Gachsaran Polymer Industries Company	<b>Gachsaran Polymer Industries Company</b> <b>HDPE Plant</b>				
	<b>LCP and Junction Box Layout,</b> <b>Arrangement and Wiring Drawing for</b> <b>Refrigerator Package</b>		 		
PO No.: GPIC-PT-MA-PO-000-3029	Document Number: VD-GPIC-MA-3029-3029-0046	Rev. 01	<b>Page 1 of 14</b>

## LCP and Junction Box Layout, Arrangement and Wiring Drawing for Refrigerator Package

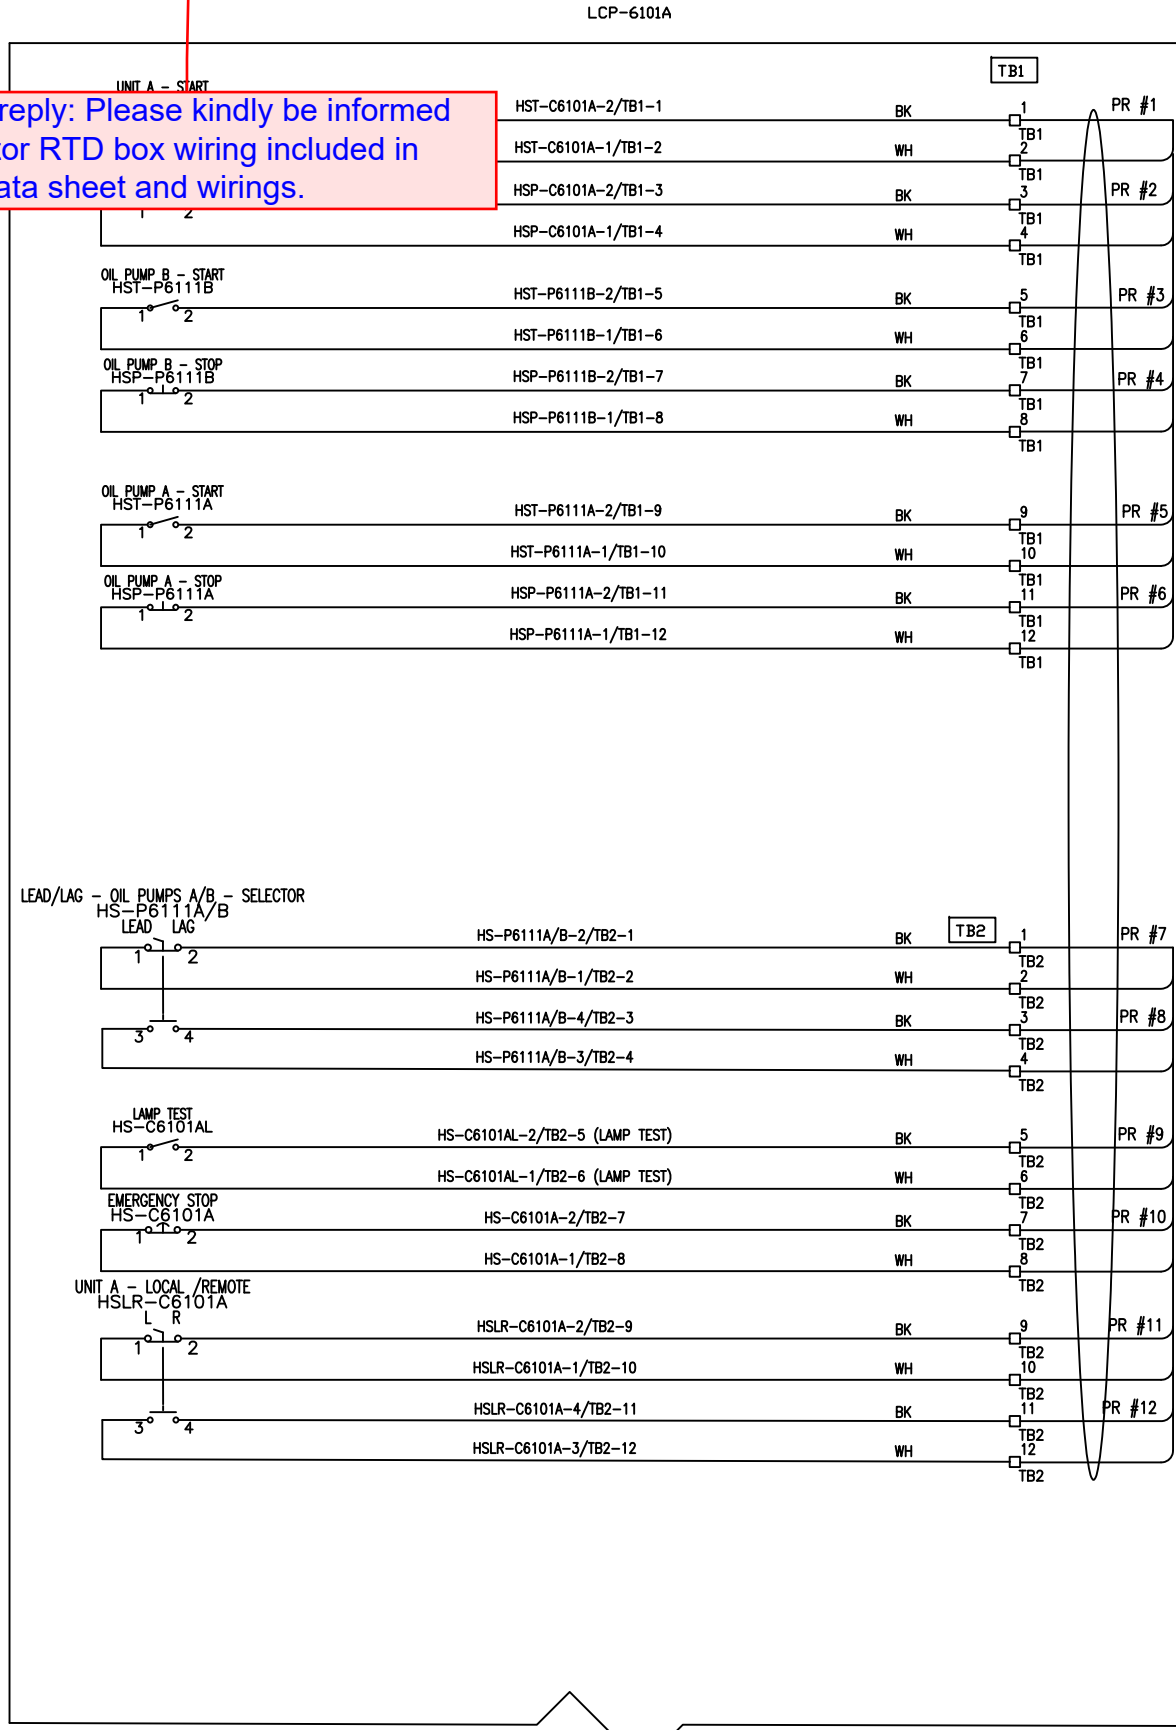
IN-01. JB wiring of motors for RTD cables which are connected to UCP shall be added to this document.

Be note that RTD for winding & Bearing shall be connected to UCP, so all I/O & Related cable shall be considered for connection in this document or related document.

Vendor reply: Please kindly be informed that Motor RTD box wiring included in motor data sheet and wirings.

Vendor Reply: Please kindly be informed tha According to MAYEKAWA design criteria and guarantee for all projects around the world including Iran projects and also client scope of work which detailed in P.21/38 of GPIC-DD-IN-SPC-000-0003-03 with considering note 1 for motor terminations and protection in MCC, Winding RTD will be monitored in MCC and just Bearing RTD will be transmitted to UCP directly. So termination could be found in motor data sheet and wiring. All documents are
